Work Order ID 132448

Item Name: Quick Release Heli-Utility-Basket™ Long, HD Lid, Spacepod™/Squirrel Check Comp.

DART SERVICE INSTRUCTION

TO AMEND INSTALLATION INSTRUCTIONS D350-607-3 Rev.D,
 INSTALLATION INSTRUCTIONS D350-607-4 Rev. C AND
 INSTRUCTIONS FOR CONTINUED AIRWORTHINESS ICA-D350-607 REV. 6
 REF TCCA STC: SH94-14
 REF FAA STC: SR00213NY
 REF EASA STC: EASA.10016996
 REF BRAZILIAN STC: 2007S03-03/-04/-05/-06

FIGURE 1: INSTALLATION OF D4775-041 FWD STRUT

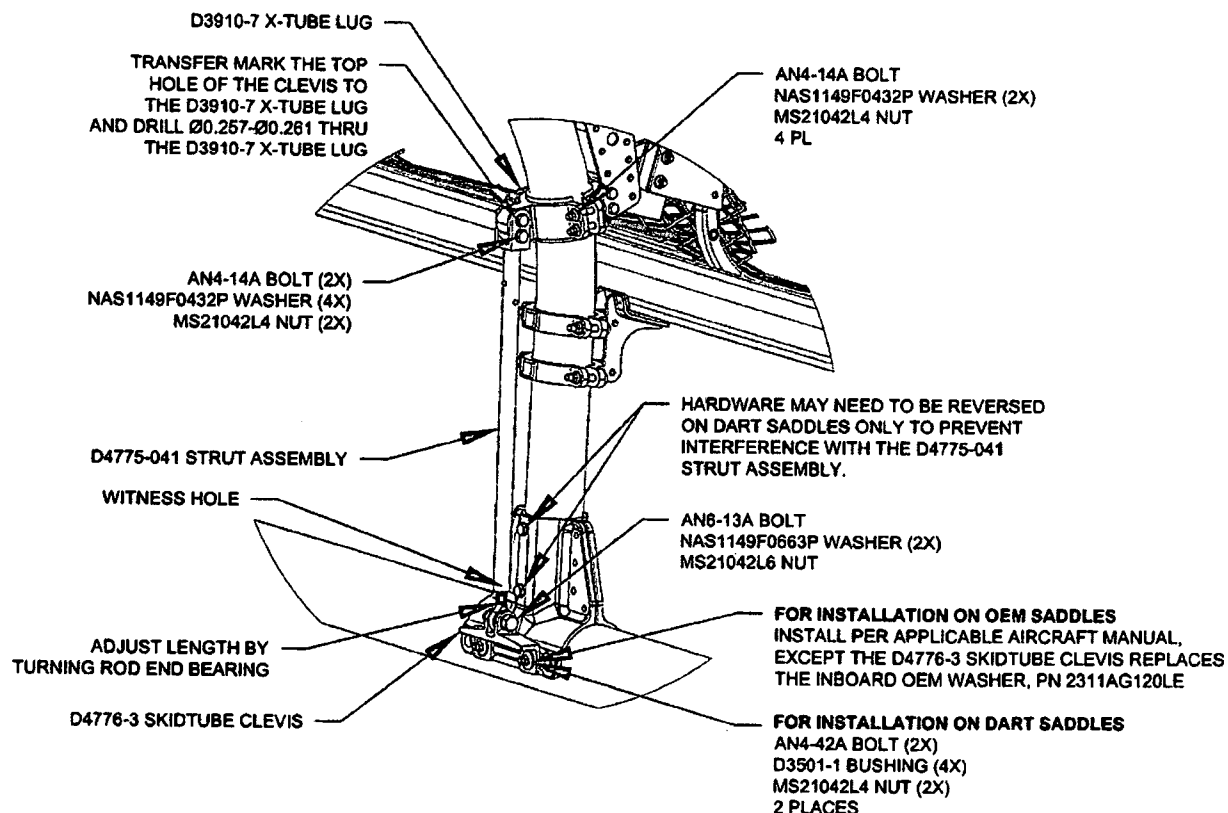
- 3.1 Substitute the Forward Lower D3910-5 X-Tube Lug with the D3910-7 X-Tube Lug as shown in Figure 1.
- 3.2 Install the forward D4775-041 Strut Assembly. Transfer mark from the upper hole on the clevis of the D4775-041 Strut Assembly to the D3910-7 X-tube Lug and drill thru the lug $\varnothing 0.257$ - $\varnothing 0.261$ as shown in Figure 1. Touch up chemical conversion coating per MIL-DTL-5541. Check the witness holes located at the bottom end of the D4775-041 Strut Assemblies to ensure that the thread from the rod end extends past the witness hole.
Torque MS21042L4/-4 nuts to 50-70 in-lbs (5.7-7.9 N-m). Torque MS21042L6/-6 nuts to 160-190 in-lbs (18.1-21.5 N-m).
- 3.3 Complete the installation in accordance with Installation Instructions D350-607-3 Rev. D or D350-607-4 Rev. C.
